Posting Title: Update to Guidelines for Inspection and Field Acceptance of Glass Fibre Reinforced Polymer (GFRP) Reinforcing Bars

TCP #: 000-0092

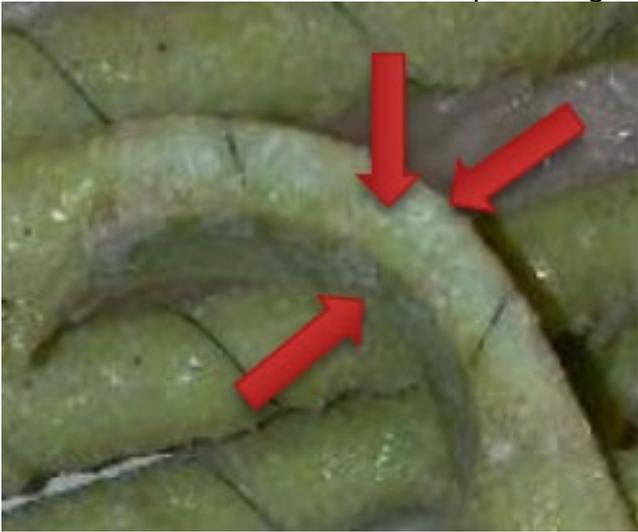
<p>Clause 4.2.3 Further clarifications needed with regards to acceptable vs nonacceptable flattening of the bar.</p> <p>Clause 4.2.3 <i>“It is acceptable for the inside surface of bent bars to be flat through the bend provided the flatness is uniform through the bend and there is no loss in cross sectional area of the bar”</i> Is there a guideline for site to identify acceptable cross-sectional area?</p> <p>Figure 23 is showing flattening at the outside of the bend, is this acceptable?</p>	<p>Some flatness of the inside radius of the bar is expected because of the forming process for bent bars. The degree of flatness is also dependent on the bend radius of bar, which is determined by design detailing and not the FRP manufacturer.</p> <p>Design instruction is provided in the <i>Structural Manual</i> and other standards and will be provided in the CDED to avoid small bend radii which result in excessive flattening or flattening of the outside of bar.</p> <p>There is no visual guideline provided for cross-sectional area of bar. The bar is expected to be round or almost entirely round, with an area that meets the requirements of CSA S807. As there is a strength reduction of bar throughout the bend, section loss is not acceptable.</p> <p>Figure 23 is in Section 4.1 which is for typical surface finish of bars. The surface finish of all the bars in the figure is acceptable. For defects, the bars would need to be evaluated on site from multiple viewing angles. From just this figure:</p>

<ul style="list-style-type: none"> • The 2nd bar is generally acceptable. There is a flat edge (top right arrow), but it appears to be at the end of bend and is likely just excess resin. • The 3rd bar is questionable. There is some excess resin with tooling marks shown with the double arrows below, and the outside face is slightly concave. Rejection would depend on where the bars are located within a structure, how often this irregular shape occurs in the production lot, and whether the flat edges are entirely excess resin or if the bar shape/fibres are also affected. 
--	---
